IMPORTANT SAFETY RECALL

NHTSA Safety Recall 26V-601 | Transport Canada NA

SUBJECT: **Campaign # 210 – Incorrect Tire and Loading Information Label**

Incorrect Tire and Loading Information Label

Parts Required – RC797227710 RECALL #210 ARKA TIRE LABEL

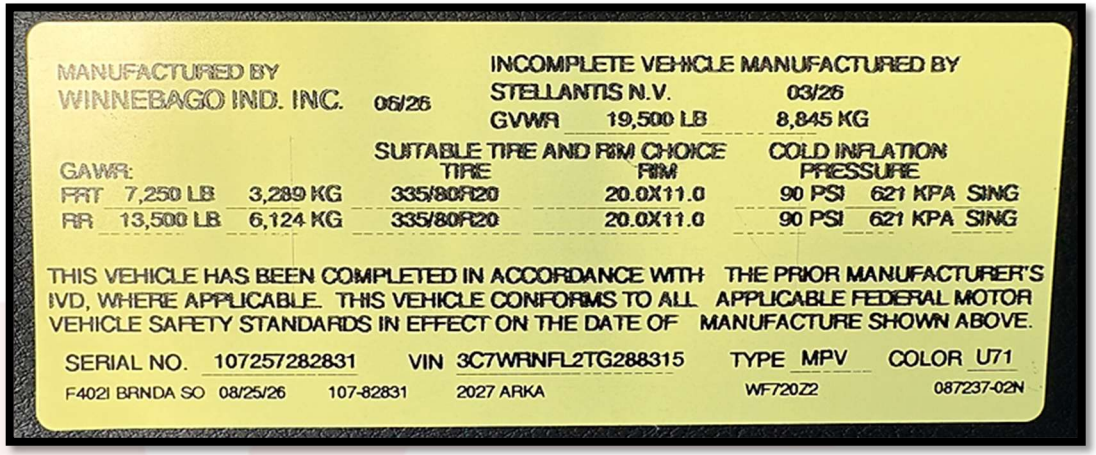
Certain Winnebago vehicles have a Tire and Loading Information Label displaying an incorrect rear GAWR and recommended cold tire inflation pressure.

Install the corrected Winnebago Tire and Loading Information Label over the existing Winnebago Tire and Loading Information Label.

1. Tire and Loading Information Label (087237-02-000) (1)

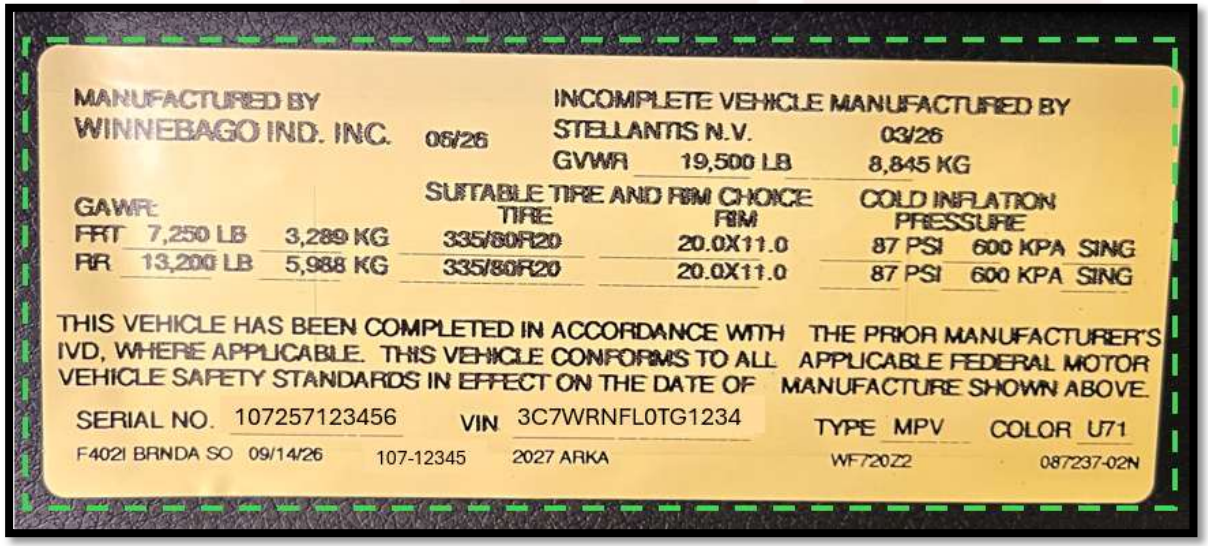
1. Locate the existing Tire and Loading Information Label inside on the Driver's Door.

2. Place the New Label over the existing Tire and Loading Information Label.

Ensure to place it over the Existing Tire and Loading Information Label, and **NOT** on the "OCCUPANT AND CARGO CARRYING CAPACITY" LABEL.
